PILATUS AIRCRAFT LTD. STANS, SWITZERLAND

SUBJECT: PRATT & WHITNEY CANADA (P&WC) SERVICE BULLETIN NO. 14432

PRATT & WHITNEY CANADA (P&WC) SERVICE BULLETIN NO. 14432 - PT6A-67B FUEL CONTROL UNIT MODIFICATION TO AVOID DIFFICULTY TO START ENGINE AT COLD TEMPERATURES

TURBOPROP ENGINE FUEL CONTROL UNIT - MODIFICATION OF

PT6A-64 Fuel Control Unit - Part Progression Figure 1

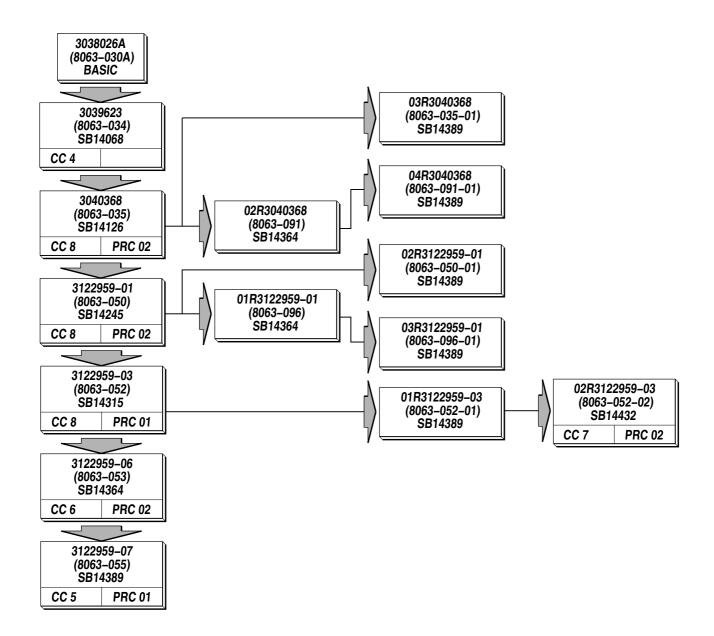
- 4. Appendix
 - A. Refer to Figure 1 for the part progression of the PT6A-64 Fuel Control Unit.
 - B. Refer to Figure 2 for the part progression of the PT6A-67B Fuel Control Unit.
